15205 ALBEMARLE RD

Re: 15205 Albemarle Road
File: 2230B (tax parcel 111-251-22)

Receipt of your application for an Improvement Permit Alteration for the above property is hereby acknowledged. Upon receipt of the information, a soil and site evaluation was conducted. The plan was then reviewed in conjunction with provisions of 15 NCAC 18A, .2900, "Laws and Rules for Sanitary Sewage Collection, Treatment and Disposal".

SOIL/SITE EVALUATION for ON-SITE WASTEWATER SYSTEM

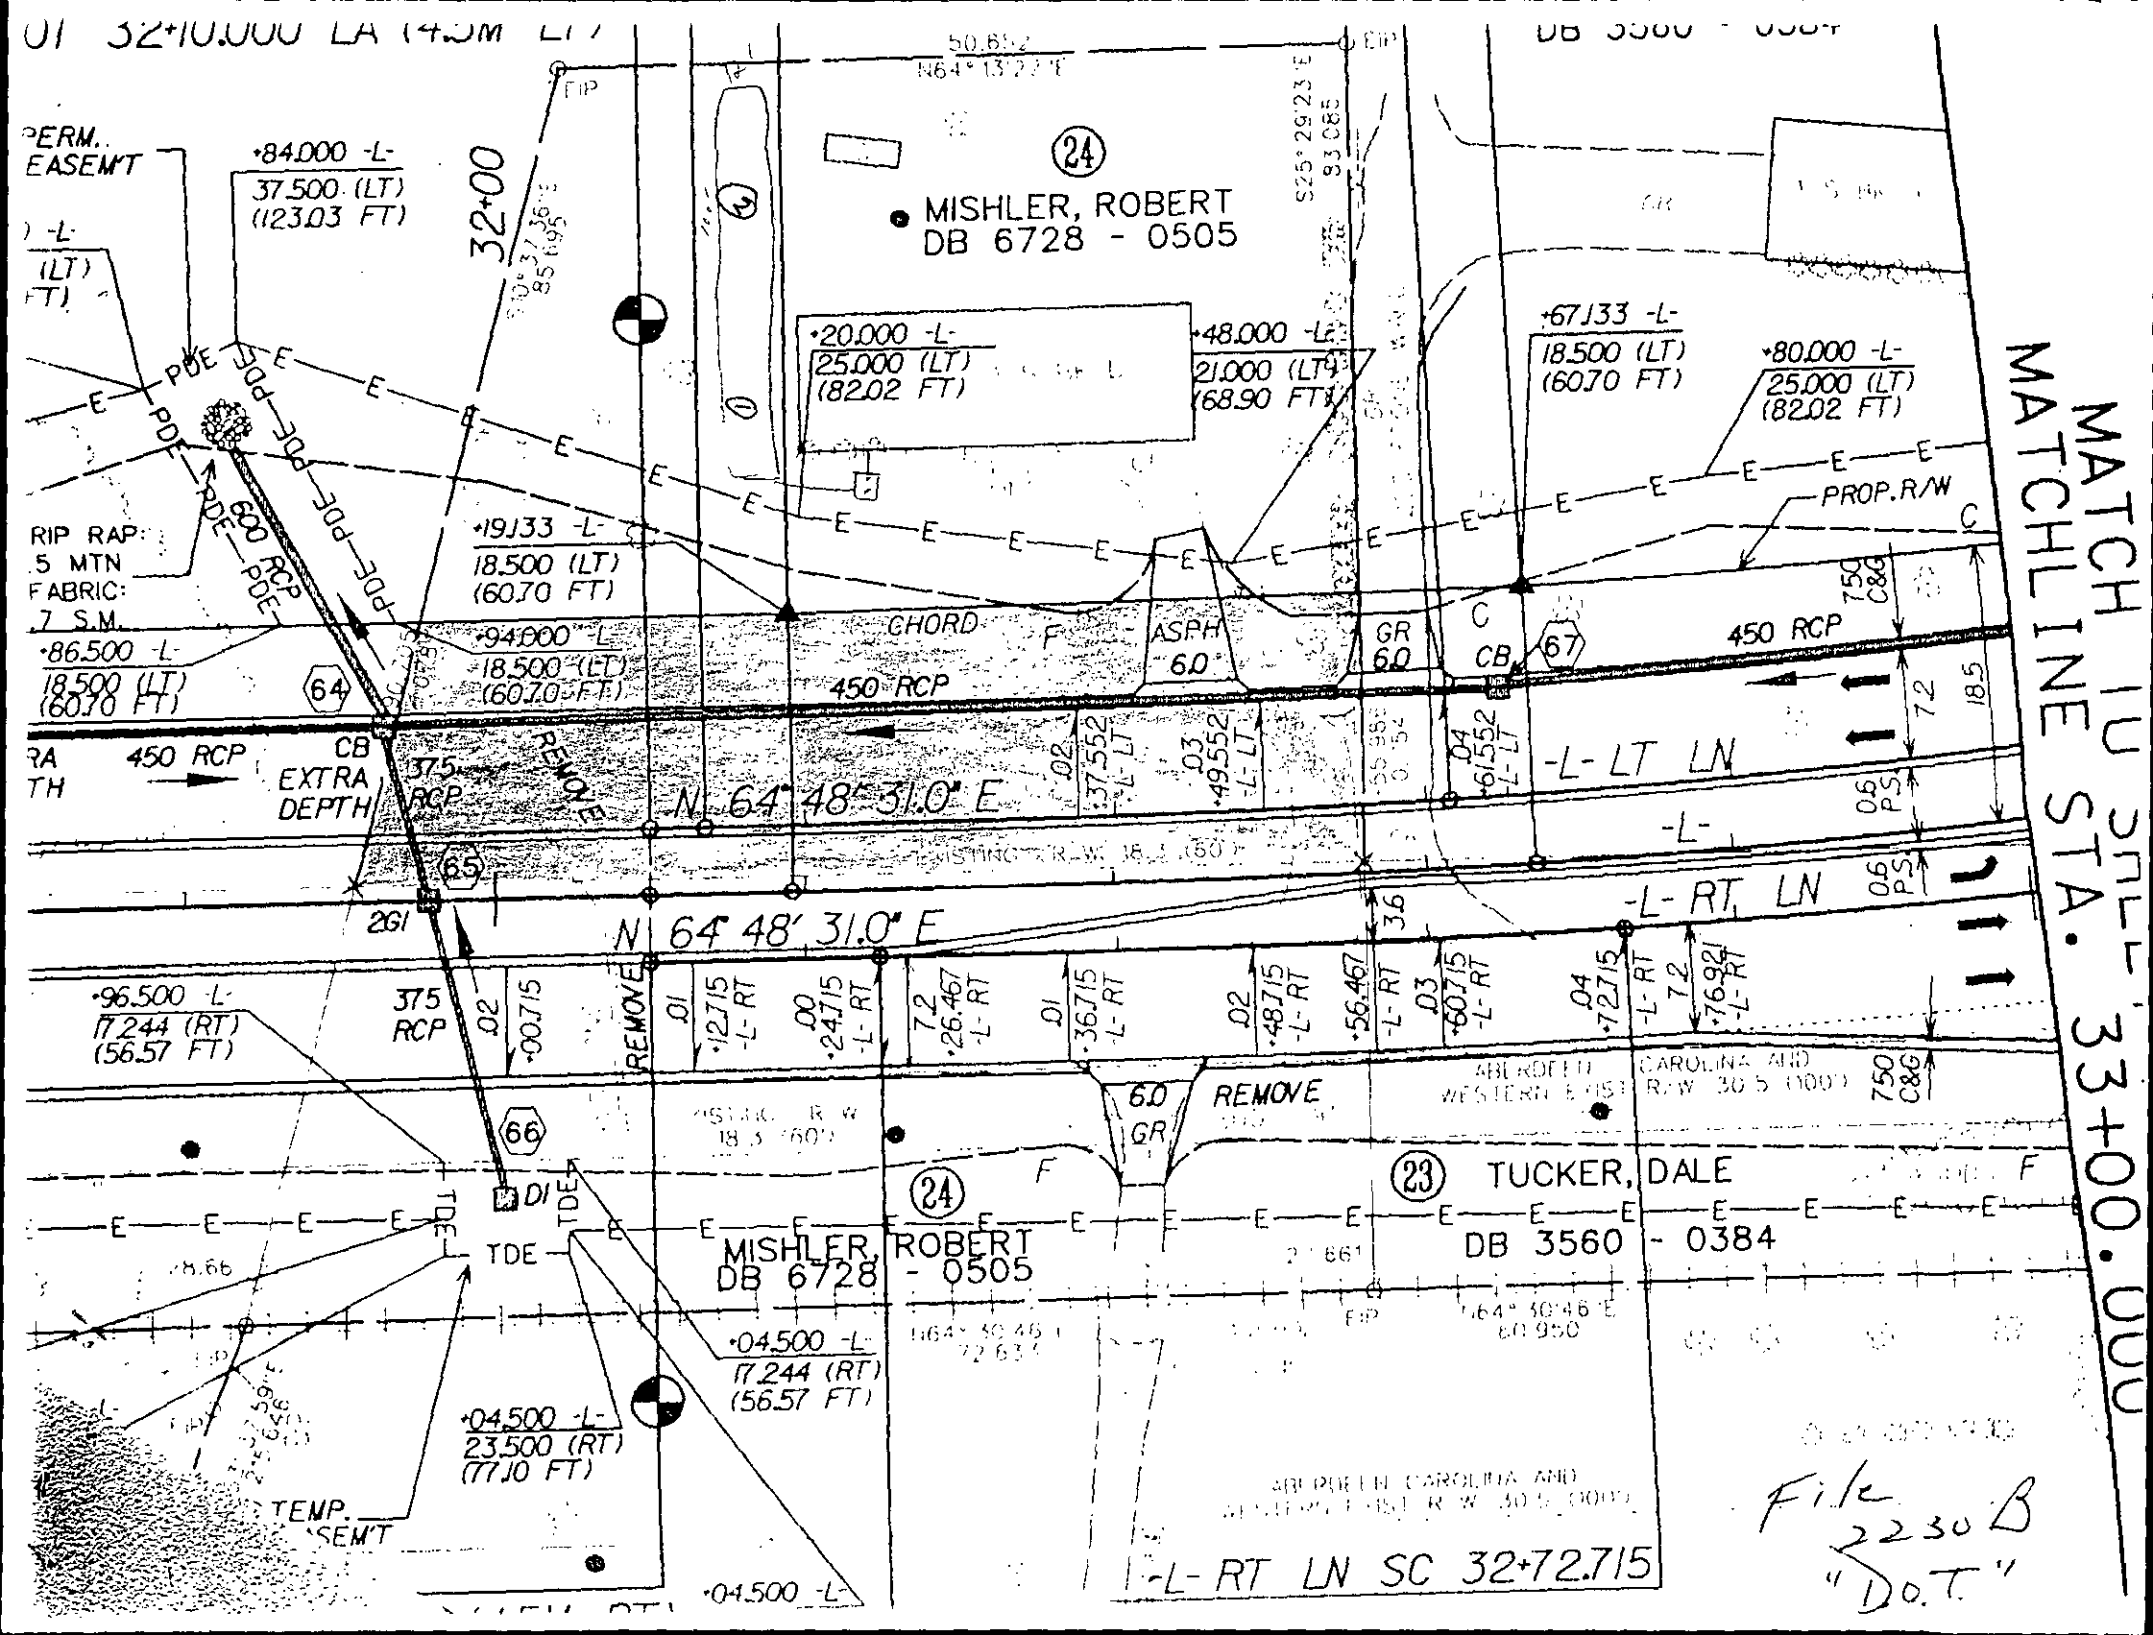
The results of the evaluation, a copy of which is attached, indicate that the site is **UNSUITABLE** for installation of a ground absorption sewage system for the following reasons:

.1941 SOIL CHARACTERISTICS (MORPHOLOGY)
(3)(B) Expansive Clay Mineralogy - Soils which have either very firm or extremely firm moist soil consistence, or have either very sticky or very plastic wet soil consistence, are considered to have predominantly 2:1 clay minerals (including mixed mineralogy clays) and shall be considered UNSUITABLE as to clay mineralogy.

.1942 SOIL WETNESS CONDITIONS
(a) Soil wetness conditions as shallow as 6 inches from soil surface

.1943 SOIL DEPTH
(a) Soil depth - saprolite 19" - 32" deep from soil surface.

9/26/97 met w/B Martin
on site (unsuitable soils)

Due to the limitations on your site, this Department is not aware of any modifications or alternative measures that can be implemented to upgrade the classification from "unsuitable" to "provisionally suitable." Your application for an improvement permit must, therefore, be denied.
